**ZONING AMENDMENT  
& SUBDIVISION STAFF REPORT****Date: June 4, 2015****APPLICANT NAME**

Alexander-Richardson Subdivision

**LOCATION**1016 and 1066 Hillcrest Road  
(Northwest corner of Hillcrest Road and Johnston Lane)**CITY COUNCIL  
DISTRICT**

# SITE PLAN

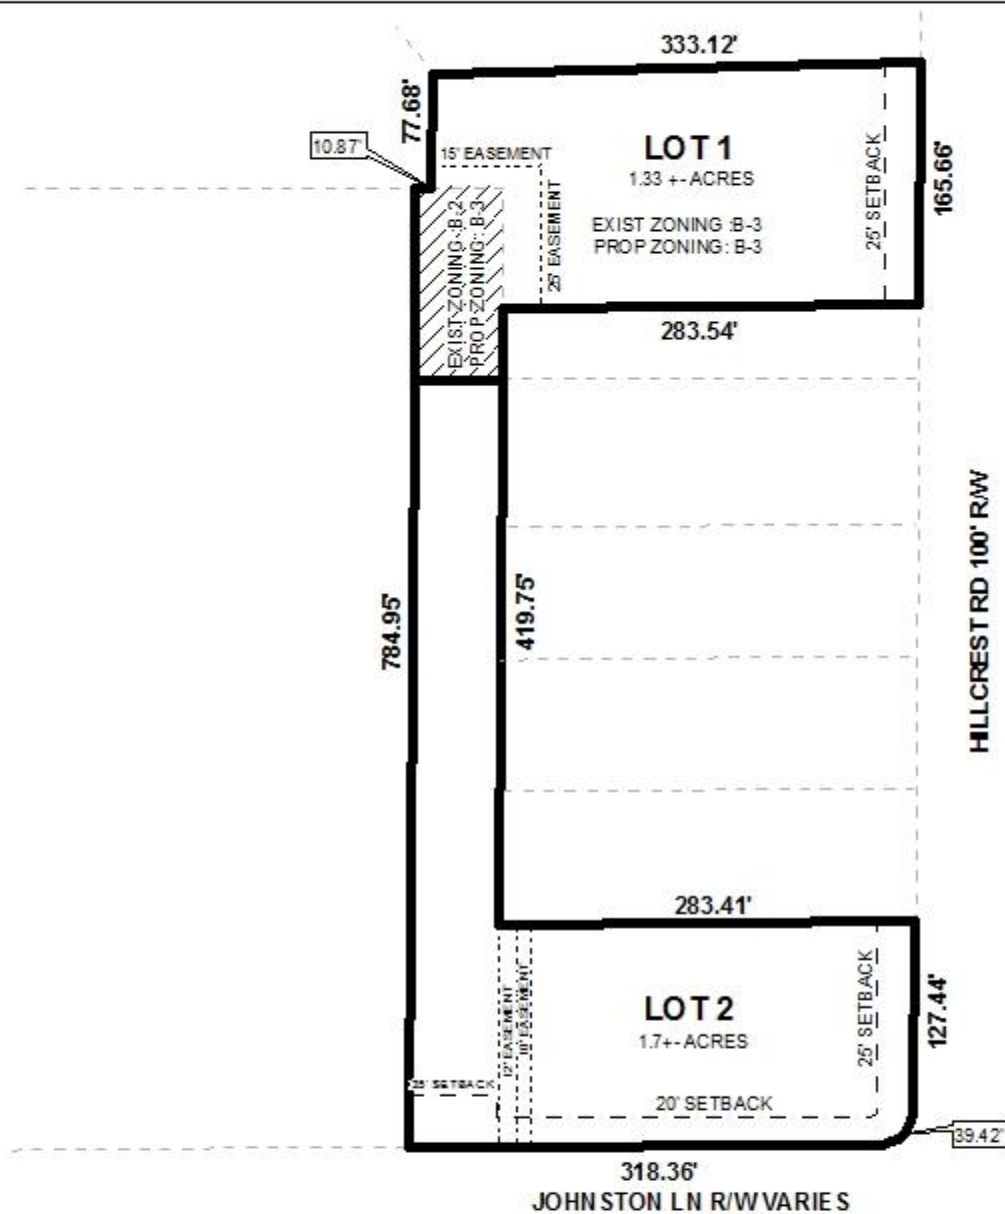
- A. Provide a legend for some the other symbols and abbreviations.
- B. Review and update, as necessary, the date of the latest FIRM panel -0537K.
- C. Show and label the monument recovered or set at each point on the boundary. Some of the symbols may be obstructed by the proposed Lot lines.
- D. Clarify the date of the field survey.

- E. Add a note to the SUBDIVISION PLAT stating that a Land Disturbance permit will be required for any land disturbing activity in accordance with Mobile City Code, Chapter 17, Storm Water Management and Flood Control); the City of Mobile, Alabama Flood Plain Management Plan (1984); and, the Rules For Erosion and Sedimentation Control and Storm Water Runoff Control.

- F. Add a note to the Plat stating that the approval of all applicable federal, state, and local agencies (including all storm water runoff, wetland and floodplain requirements) will be required prior to the issuance of a Land Disturbance permit.

- G. Add a signature block for the Owner, Notary Public, Planning Commission, Traffic Engineer, and City Engineer.
- H. Add a note that sidewalk is required to be constructed, and/or repaired, along the frontage of each lot, or parcel, at time of development, unless a sidewalk waiver is approved.

- I. Provide the Surveyor's, Owner's (notarized), Planning Commission, and Traffic Engineering signatures.
- J. Provide a copy of the Final Plat along with the original when submitting for City Engineer signature.

As on the preliminary plat the Final Plat should retain the lot size labels in both square feet and acres, or a table should be furnished on the Final Plat providing the same information. And as on the preliminary plat, the Final Plat should retain the 25' minimum building setback lines along all street frontages, except the 35' setback line near the West end of Lot 2.

- 1) placement of a note on the Final Plat stating that Lot 1 is limited to two curb cuts to Hillcrest Road, with the size, location and design to be approved by Traffic Engineering and conform to AASHTO standards;
- 2) placement of a note on the Final Plat stating that Lot 2 is limited to the existing curb cuts to Hillcrest Road and Johnston Lane;
- 3) retention of the lot sizes in both square feet and acres on the Final Plat, or the furnishing of a table on the Final Plat providing the same information;
- 4) retention of the 25' minimum building setback lines along all street frontages, except the 35' setback line near the West end of Lot 2;

- 6) completion of the Rezoning process prior to signing the Final Plat;
- 7) full compliance with the Engineering comments: *[The following comments should be addressed prior to submitting the FINAL PLAT for acceptance and signature by the City Engineer: A. Provide a legend for some the other symbols and abbreviations. B. Review and update, as necessary, the date of the latest FIRM panel -0537K. C. Show and label the monument recovered or set at each point on the boundary. Some of the symbols may be obstructed by the proposed Lot lines. D. Clarify the date of the field survey. E. Add a note to the SUBDIVISION PLAT stating that a Land Disturbance permit will be required for any land disturbing activity in accordance with Mobile City Code, Chapter 17, Storm Water Management and Flood Control); the City of Mobile, Alabama Flood Plain Management Plan (1984); and, the Rules For Erosion and Sedimentation Control and Storm Water Runoff Control. F. Add a note to the Plat stating that the approval of all applicable federal, state, and local agencies (including all storm water runoff, wetland and floodplain requirements) will be required prior to the issuance of a Land Disturbance permit. G. Add a signature block for the Owner, Notary Public, Planning Commission, Traffic Engineer, and City Engineer. H. Add a note that sidewalk is required to be constructed, and/or repaired, along the frontage of each lot, or parcel, at time of development, unless a sidewalk waiver is approved. I. Provide the Surveyor's, Owner's (notarized), Planning Commission, and Traffic Engineering signatures. J. Provide a copy of the Final Plat along with the original when submitting for City Engineer signature.];*
